PERMIT

SEWAGE DISPOSAL SYSTEM

HOWARD COUNTY HEALTH DEPARTMENT

SUBDIVISION Roger's Avenue Realty Prop. LOT 2 ROAD 2714 Route 32 Sykesville Rd

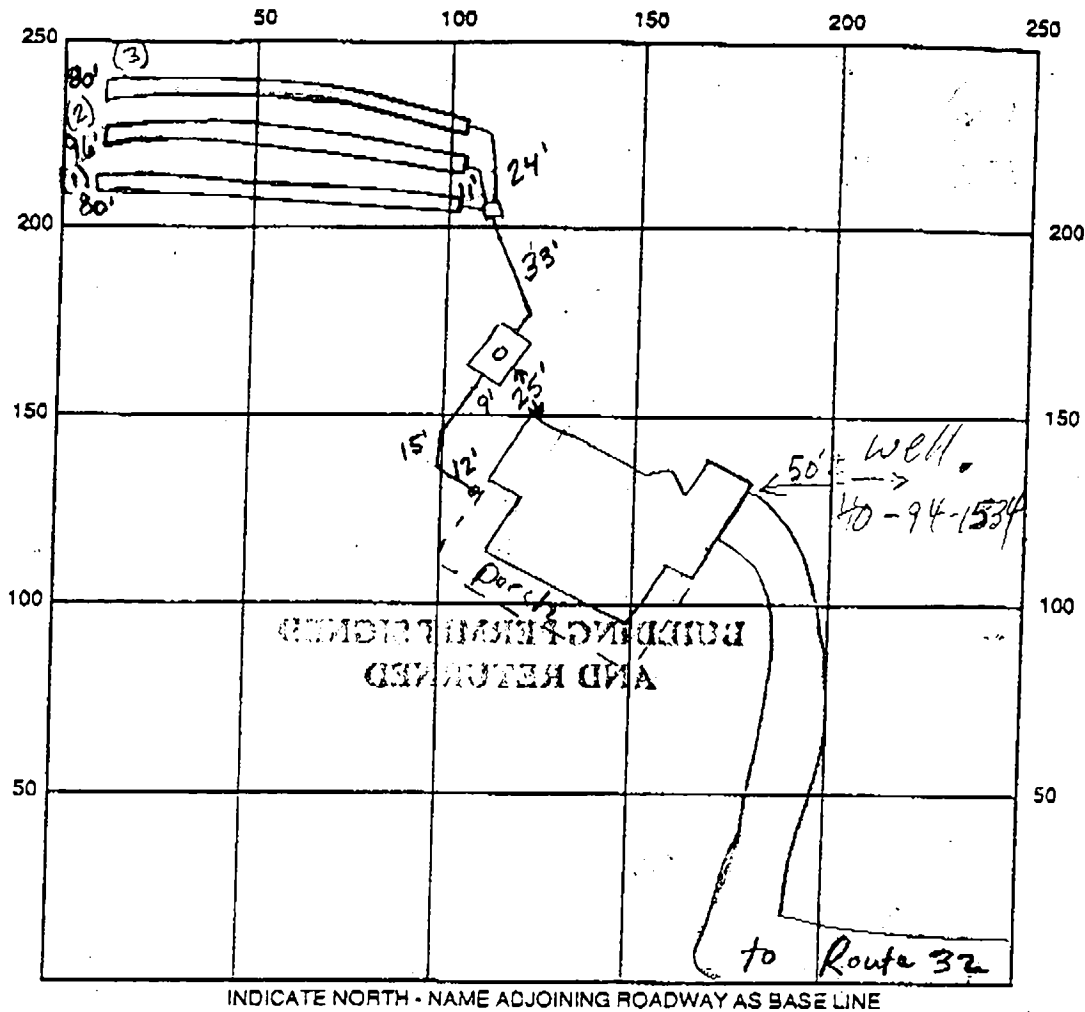
FT. → 256NUMBER OF TRENCHES 3ONE SIDEWALL/BOTTOM AREA 758 SQ. FT.DRYWALL INSIDE DIAMETER — FT.EFFECTIVE DEPTH BELOW INLET — FT.ABSORBENT AREA — SQ. FT.REMARKS: 11/30/98 inlet deeper than specified, ok due to suitable soils and to achieve gravity flow, ok to stone 1st trench and continue (KM)12-1-98 ok to stone 2nd trench and continue (KM)12-2-98(am) ok to cover 2nd trench and continue 3rd trench (KM)12-2-98(pm) ok to stone and cover 2nd and 3rd trench, leave end of 3rd trench open (KM) 12/3/98 OK to cover all workDATE SYSTEM APPROVED 12/3/98INSPECTOR A McMillan

WALL CHECK

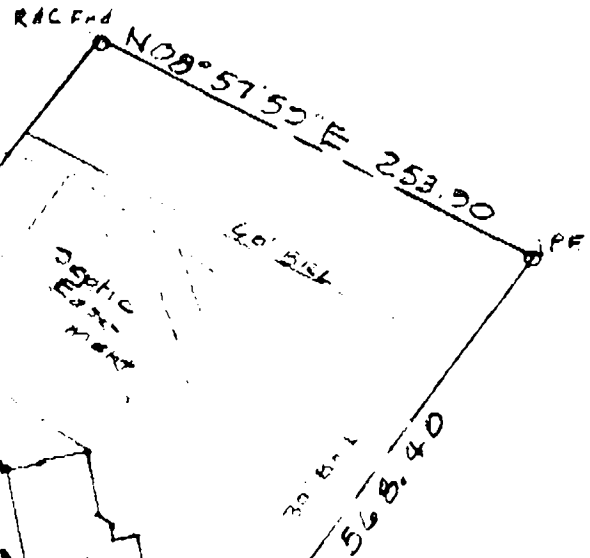
House moved back
377' from 229.42
lot line (closer to septic
easement). Owner stated
that house is still 20'
from septic easement.

11/10/98 Confirmed in field that
house corner is 20' from septic.

SITE PLAN

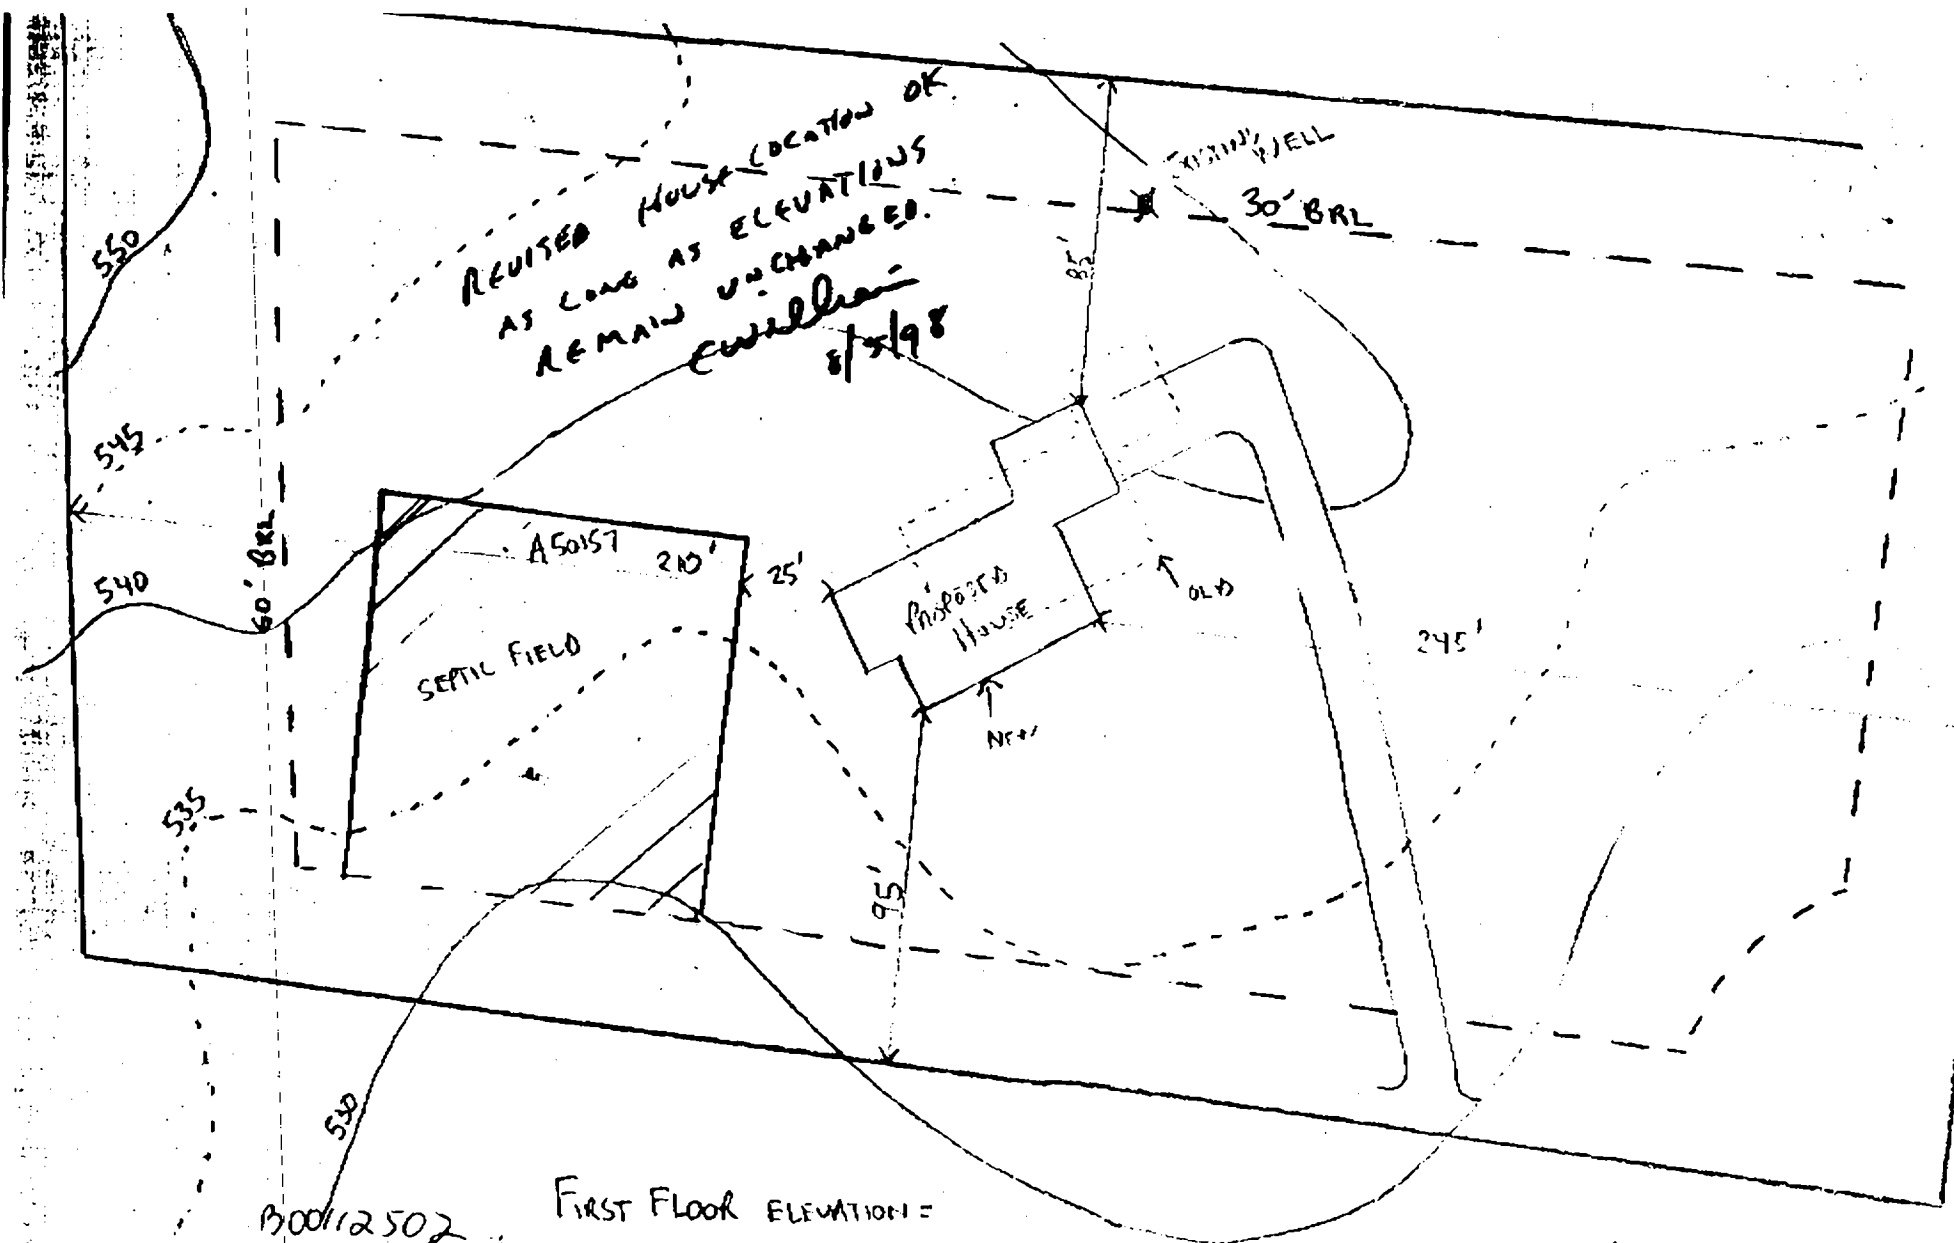
REVISED HOUSE LOCATION OK
AS LONG AS ELEVATIONS
REMAIN UNCHANGED.
C. Williams
8/5/98

Comments: relocated House
